**BLM SCALAR FIX** -Based on findbhudda's original design:  
<http://www.midibox.org/dokuwiki/doku.php?id=findbuddha>

Corrected blm-scalar v1.1.brd below & attached: [blm-scalar\\_v1.1.zip](#)

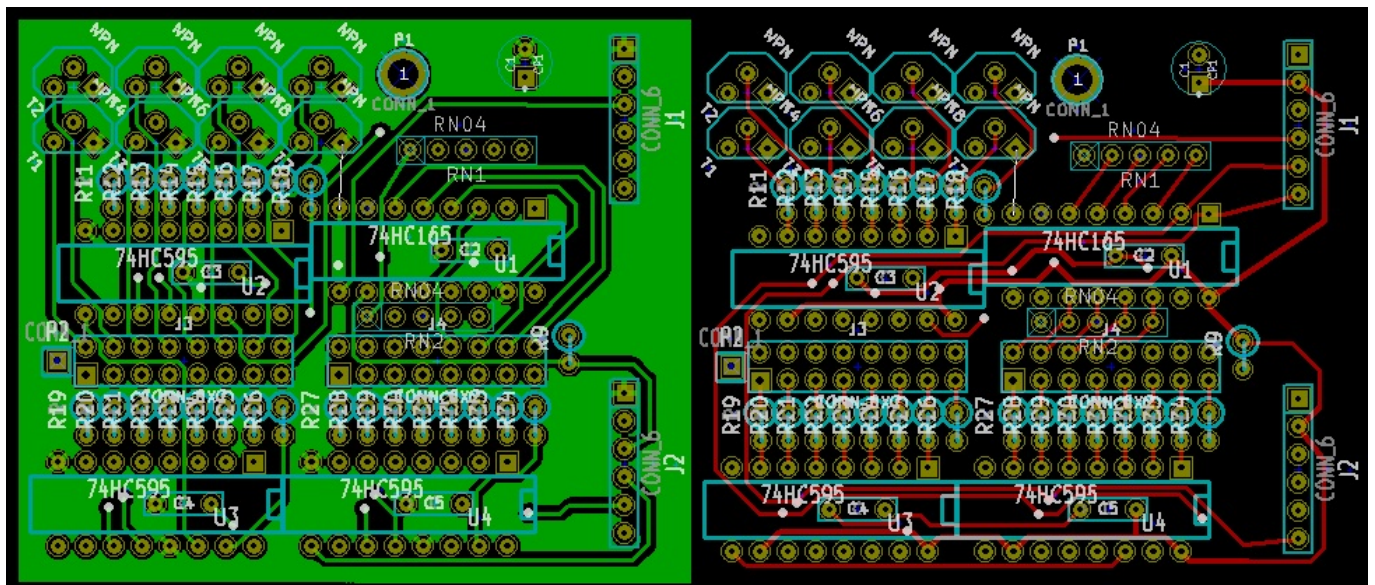
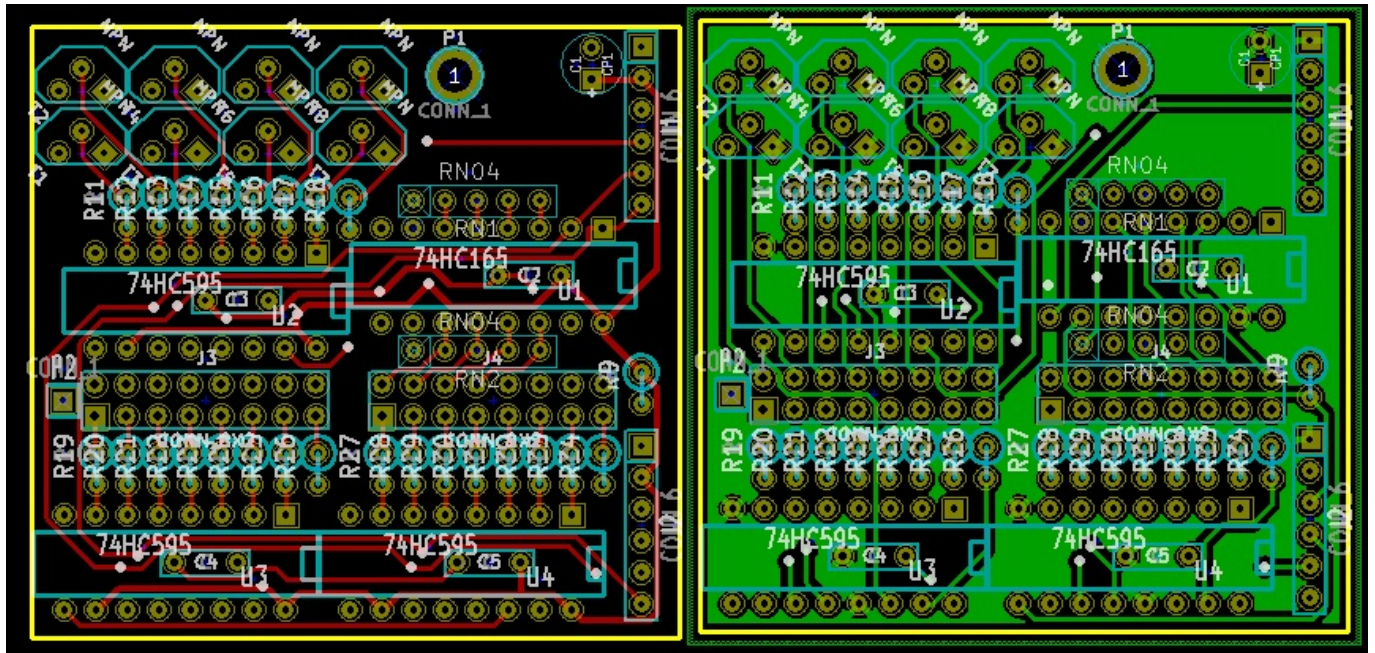
- blm-scalar.\* contain an error. Pins I4-I7 are mirrored. This is easily fixed with a connector modification, and the blm-scalar module seems to work as intended.
- blm-scalar v1.1 attempts to fix this error. Moved connectors J1, J2 & Resistor Net 1 to make room for corrections.
